*Landscape
Design Guidelines
for
North Central
Roseville
Specific Plan*

City of Roseville

LANDSCAPE DESIGN GUIDELINES ERRATA
NORTH CENTRAL ROSEVILLE SPECIFIC PLAN

Amendments approved by City Council 8/18/93

Figure 3-9a
 Soundwall and Pilaster
 at Collectors A and B
 along Single-Family Parcels

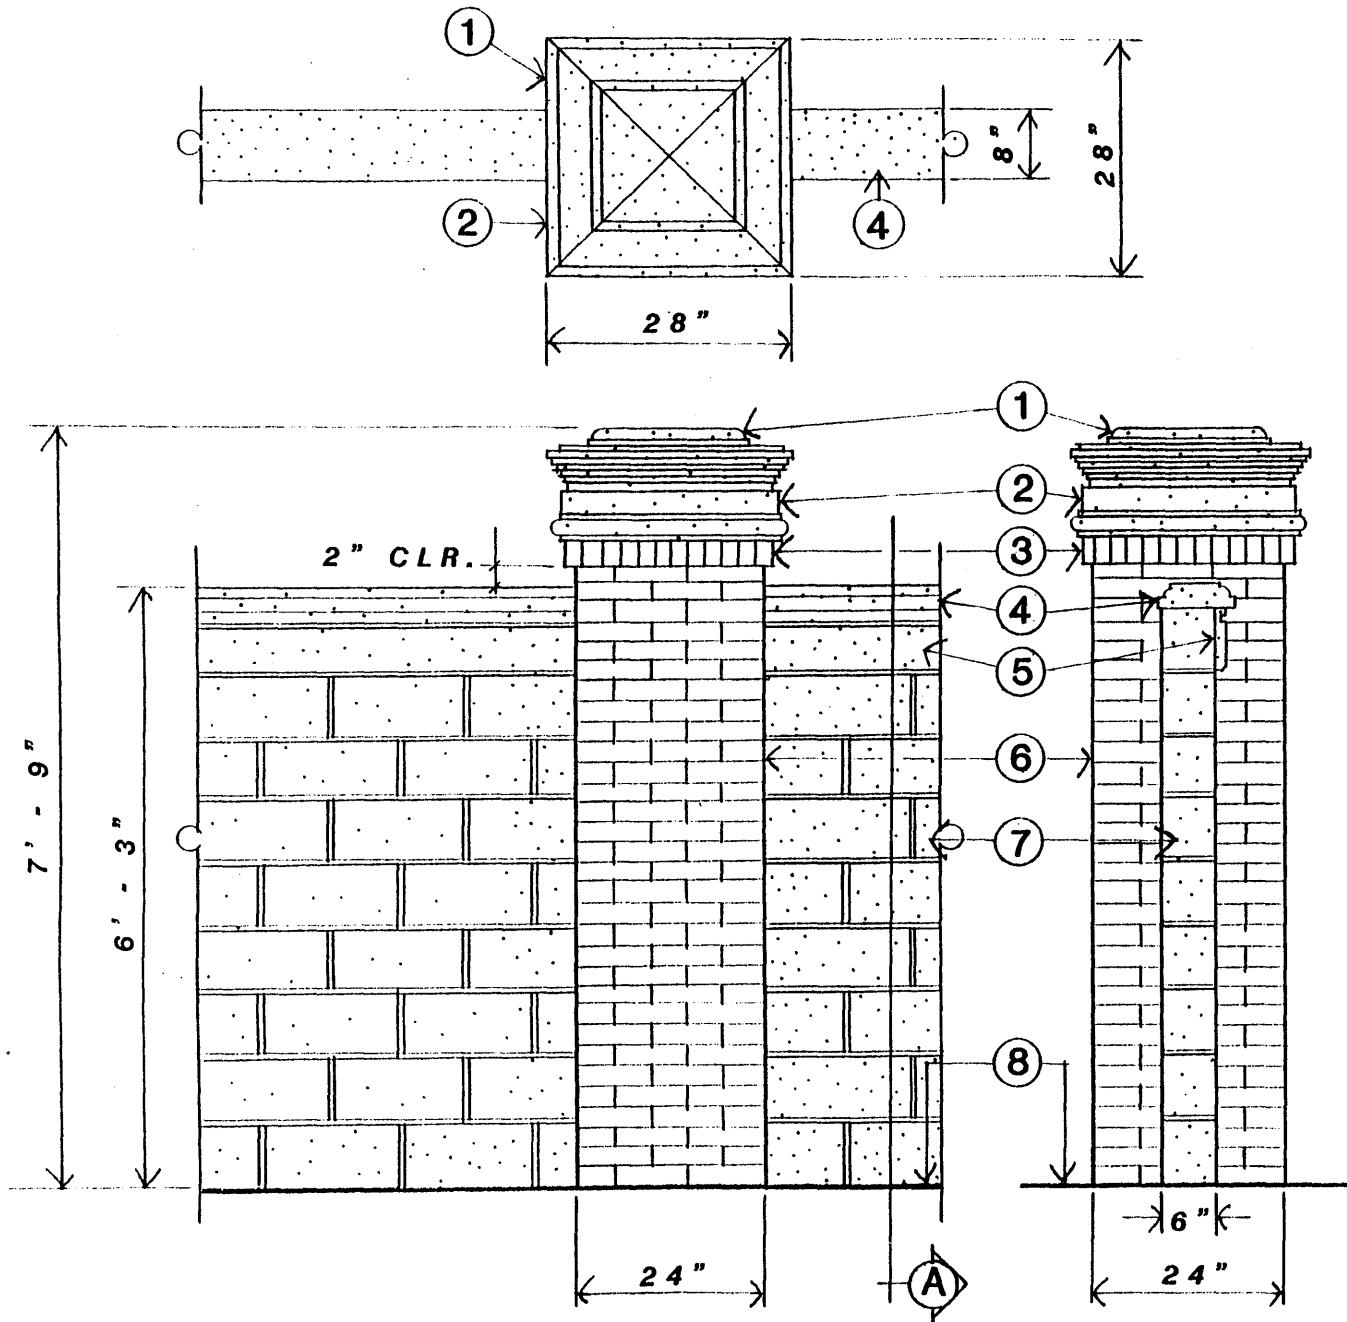
Figure 3-9a, Note D, page 3-18: Set pilasters at ~~120' 0" on-center as shown on Figure 3-9d.~~

Figure 3-9b
Soundwall and Pilaster

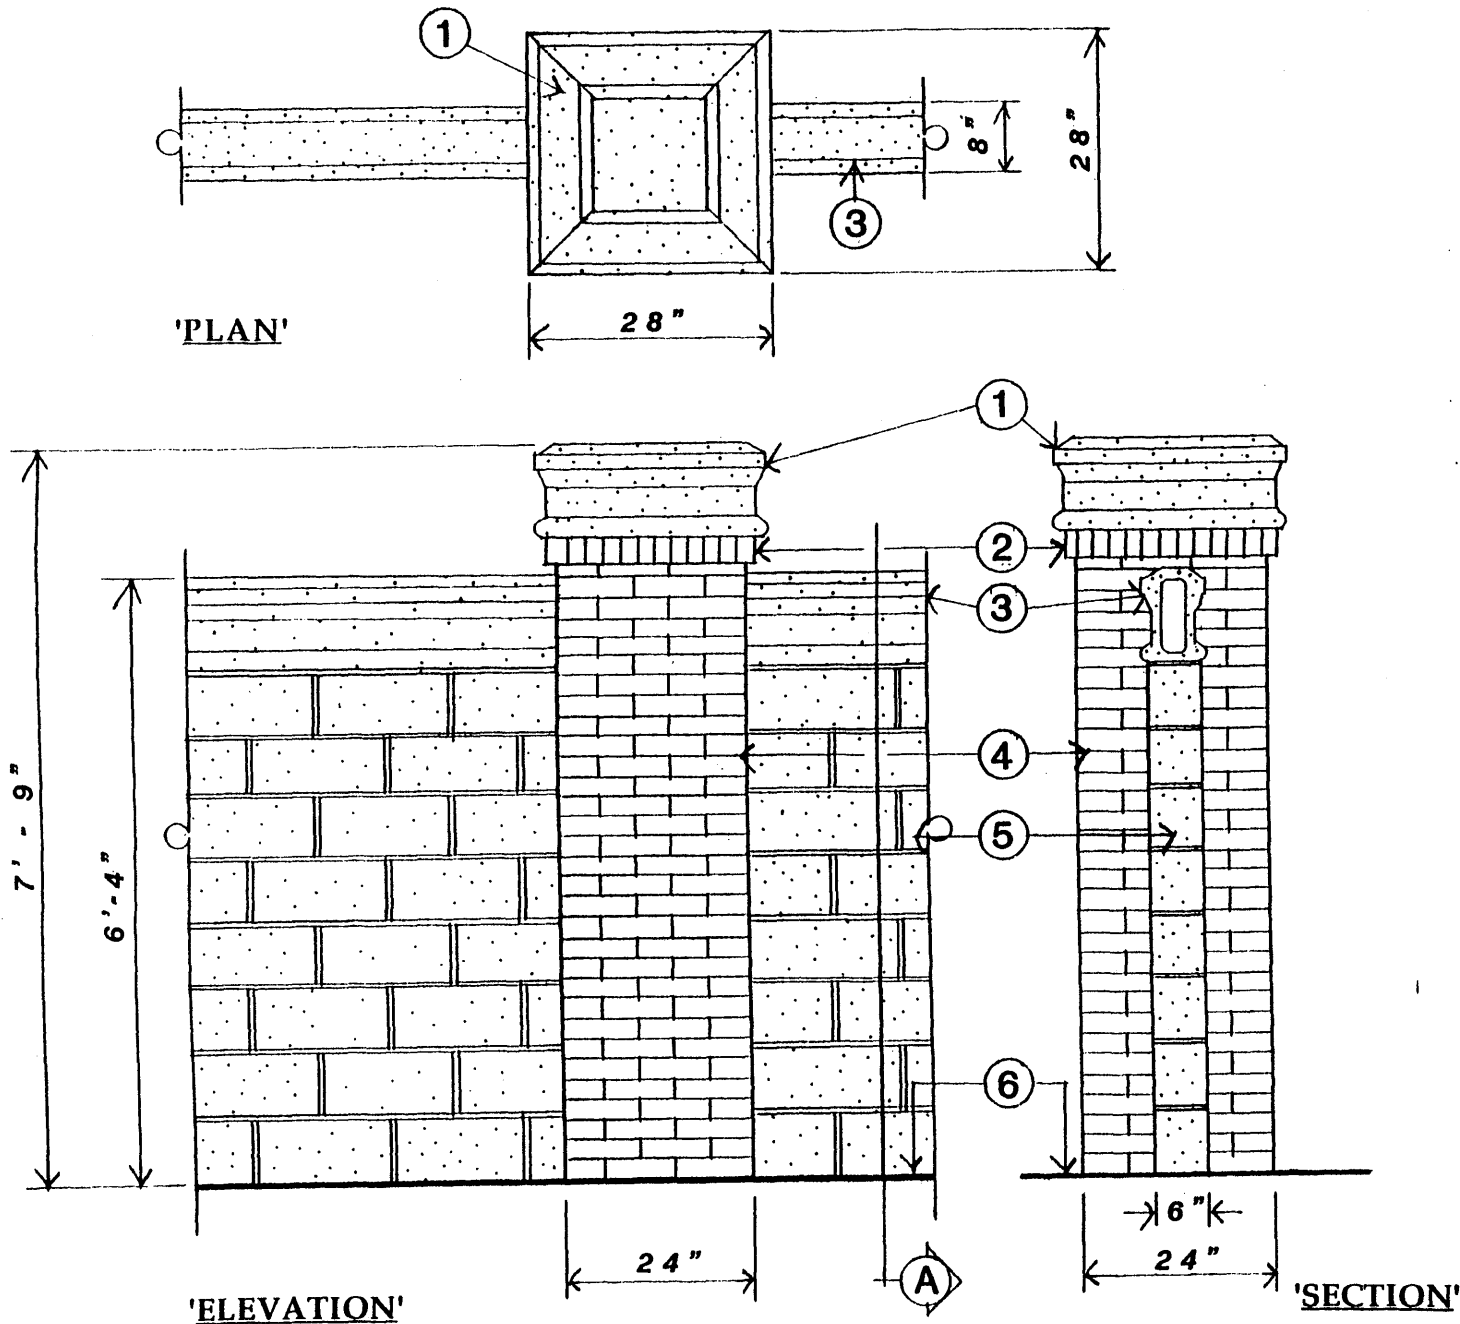
Figure 3-9b, Note D, page 3-19: Set pilasters at ~~120' 0" on-center as shown on Figure 3-9d.~~
